## *Request for Proposal* *City of Fort Lauderdale*

PROJECT: Merle Fogg Park Seawall  
Replacement  
EBSARY Foundation  
CONTRACTOR: Company

PROPOSAL NUMBER: 002  
DATE: 11/17/2023  
HAZEN JOB NUMBER: 43193-014

PROJECT # 12726  
SOUTHEAST ISLES NEIGHBORHOOD  
MERLE FOGG PARK SEAWALL REPLACEMENT  
SITE PLAN AND SECTION -  
SEAWALL 18A

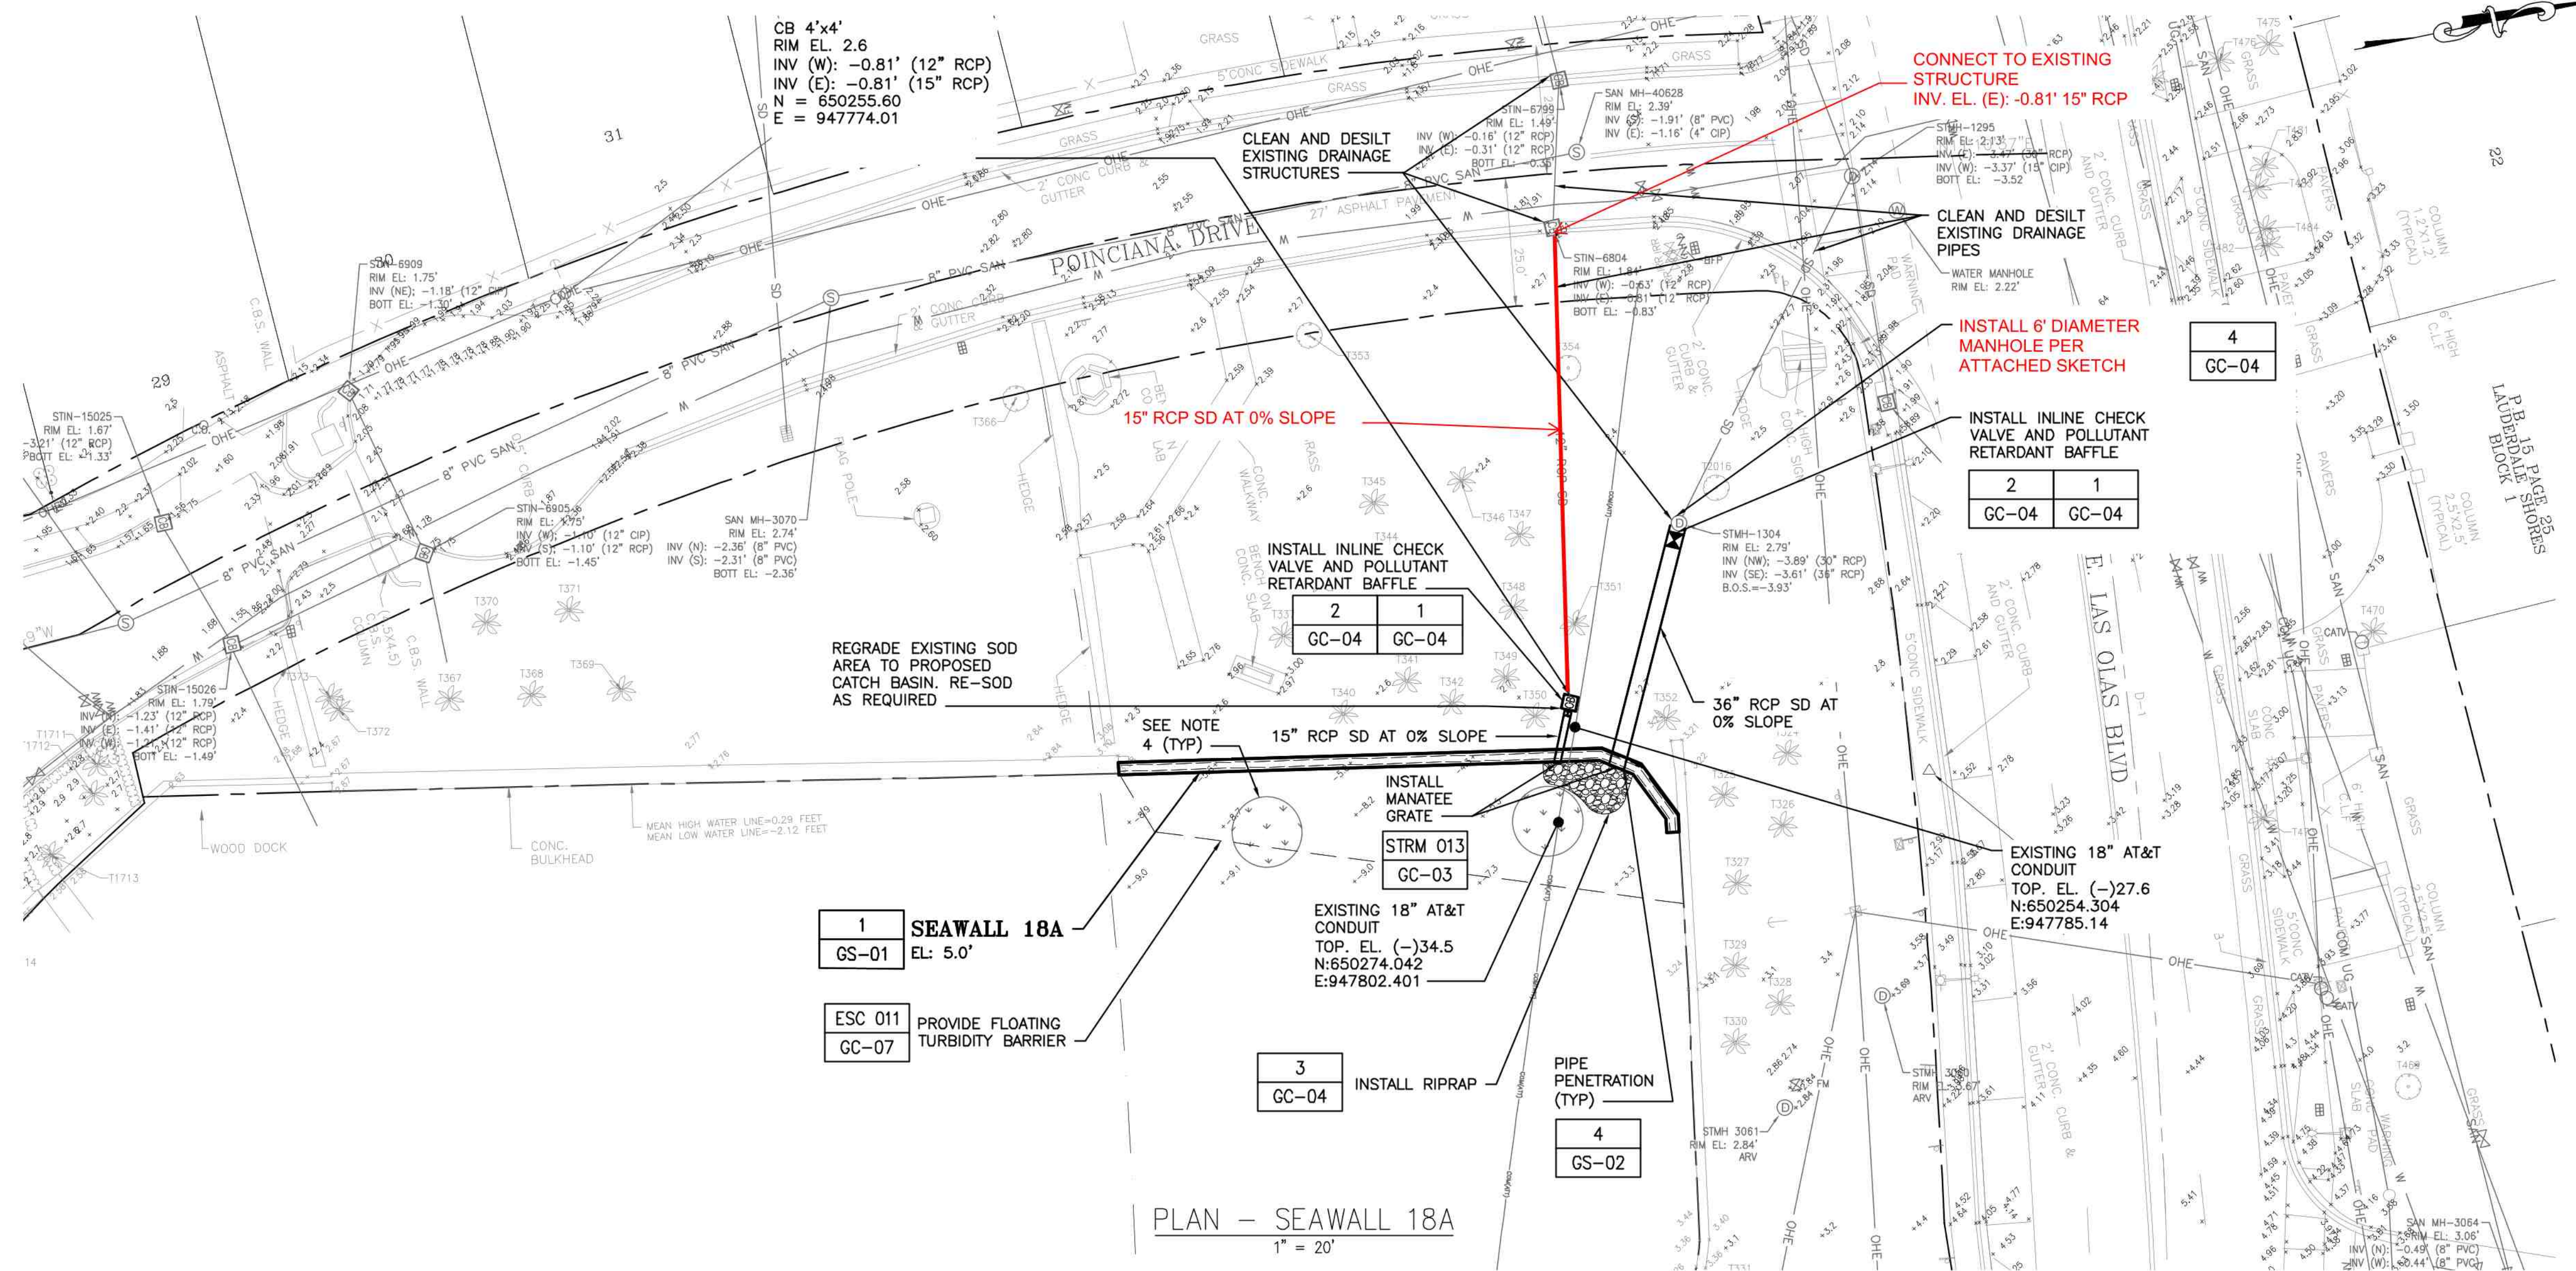
1. Replace existing manhole STMH-1304. This work includes, but is not limited to, the following:
  - Removal and disposal of existing manhole structure.
  - Furnishing and installing a 6' diameter manhole in accordance with the attached sketch and Detail STRM 009 on Drawing GC-03. All manhole dimensions must be field verified.
  - Connection of new manhole with existing 30-inch RCP upstream. The diameter of the existing pipe to be connected shall be confirmed by the Contractor.

2. Replace existing 12" CMP. This work includes, but is not limited to, the following:
  - Removal and disposal of existing 12" CMP between proposed catch basin and existing STIN-6804. Quantity that is not included in the original bid tabulation shall be included in the Proposal (approximately 70 LF).
  - Furnishing and installing 15" RCP (alternatively 15" high-performance polypropylene pipe) from proposed catch basin to existing STIN-6804 as shown in the attached sketch in accordance with the Contract Documents. Quantity that is not included in the original bid tabulation shall be included in the Proposal (approximately 70 LF). Contractor to confirm total length of 15" RCP.
  - Connection of proposed 15" RCP to existing catch basin STIN-6804.
